LARKIN PLACE SUBDIVISION A PART OF THE N. E. 1/4 OF SEC. 7 AND THE N. W. 1/4 OF SEC. 19, T. 6 N., R. 2 W., S. L. B. & M. WEBER COUNTY, UTAH

Engineering

Project: [Larkin Place Subdivision](#)
User: [Michael Tuttle](#)
Department: [Weber County Engineering Division](#)
Created: 2012-06-06 11:59:44
Modified: 2012-06-18 17:13:22

Weber Fire District Review

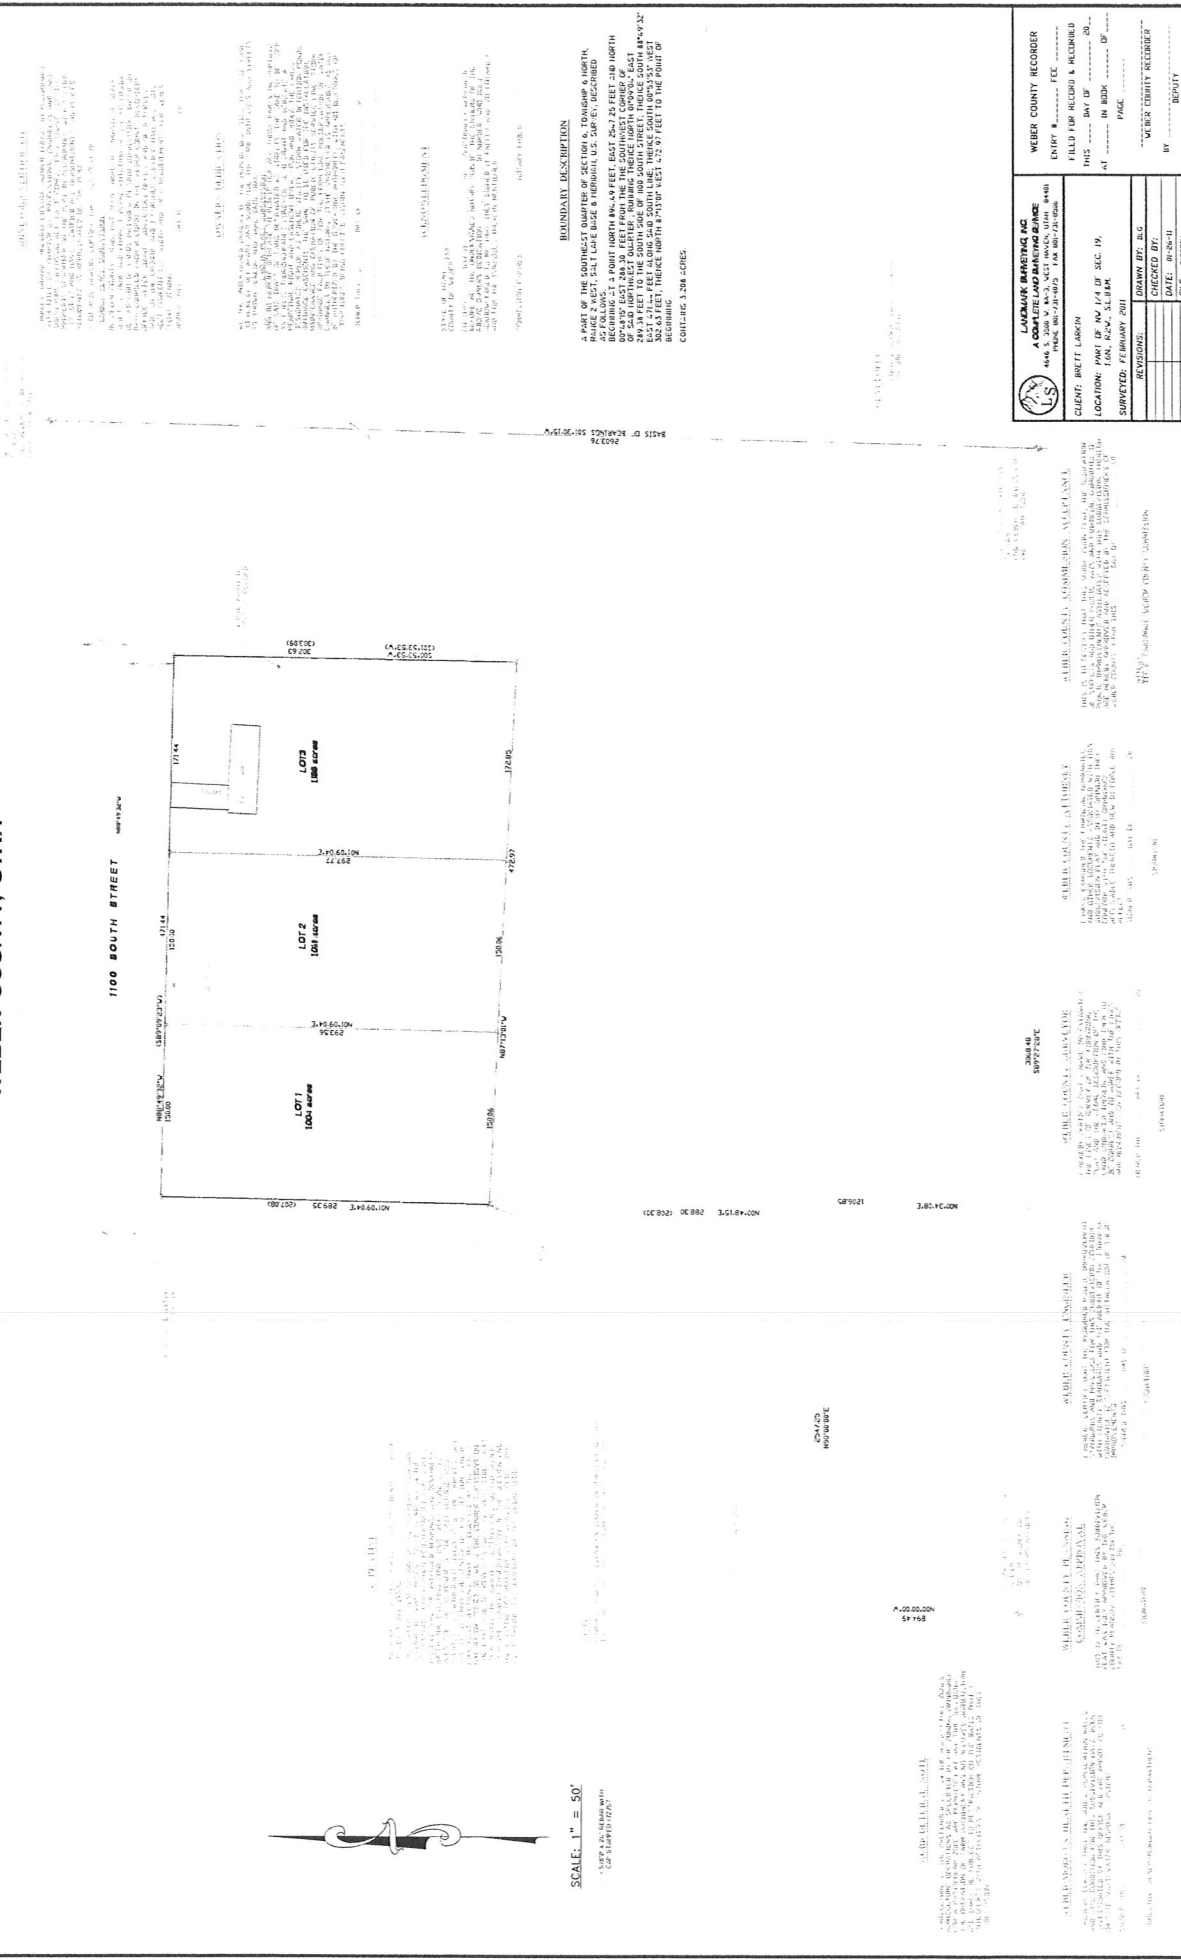
2. The east edge of the plat states "1 ROD RIGHT OF WAT OF RECORD" I assume that this is supposed to be WAY instead of WAT.
 3. Is there any road way being dedicated, or is it already an existing 80' ROW?

5. Is the ditch out front in the ROW or on the private property. If it's in the ROW it will need to be piped. If the curb, gutter and sidewalk are deferred, then the grade will need to be brought up to a foot below the edge of asphalt.

6. There will need to be an easement given for the existing ditches in the subdivision.
 7. An excavation permit is required for all work done within the existing right-of-way.
